**6672A-07A**

**S E R V I C E N O T E**

**6672A DC POWER SUPPLY GPIB CONTROLLED**

**The Current Shunt (Circuit Reference “R907”) may have intermittent sense wires, which may cause Instability of Current regulation, Current read back and current programming.**

A6 Output Assembly for Models (65/6671A, 65/6672A)

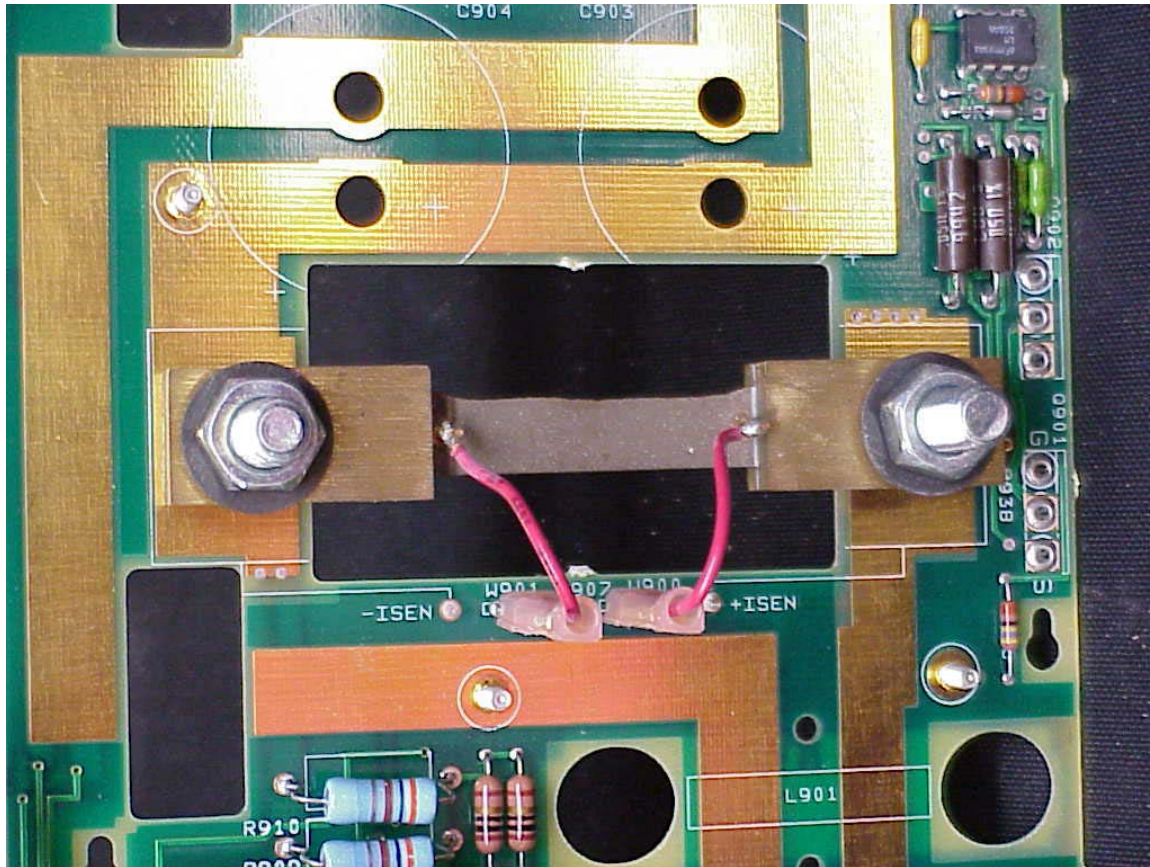
When the push-on connectors become intermittent the output current will become unstable. Loose push-on connectors can cause the output current to change dramatically. The current can change from any set current, and may go to the maximum rated output current of the instrument.

This picture shows how the Shunt R907 is connected using the term-crimp connectors.

The Shunt R907 is connected to "W900" & "W901"

Cut the terminal-crimp connectors off of both wires and discard the connectors. Make this cut as close to the terminal-crimp connector as possible. The required strip length should be 5mm. This strip length will be used to prevent the wire length being too long and shorting to the instrument chassis. If replacement of this wire is required any color (22 AWG, 300V 105C) wire type can be used.

This modification can be done from the top of the board. Carefully strip and solder the wires, and avoid burning the wire insulation and the printed circuit board.

The wires should be connected as shown below. The two holes marked -ISEN & +ISEN should be used. Do not cross the wires when making this modification. See picture below for details. This picture shows the required modification.
